RECALL: NHTSA 22V156

SUBJECT: Incorrect Front tire pressure on Placard Label and Tire Pressure Label

APPLIES TO: Roadtrek: 2020 and 2021 SS Agile models

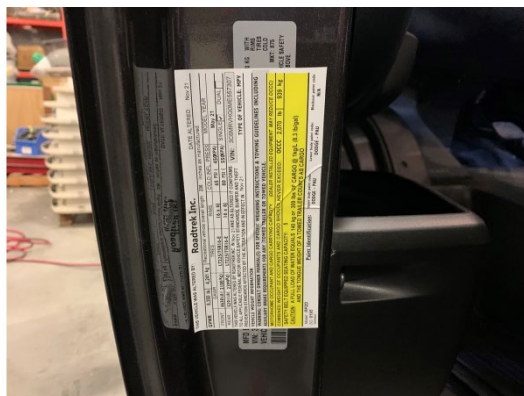
CONDITION: Placard and Tire Pressure labels incorrectly state the front tire pressure as 46 psi

STEP 1: Find the location of the Placard label on the side of the driver's door.

CORRECTION: Placard label and Tire Pressure label need to be replaced with new labels that state the front tire pressure as **52 psi**

STEP 3: Peel off the backing of the new placard label and apply it over top of the original label with the same orientation
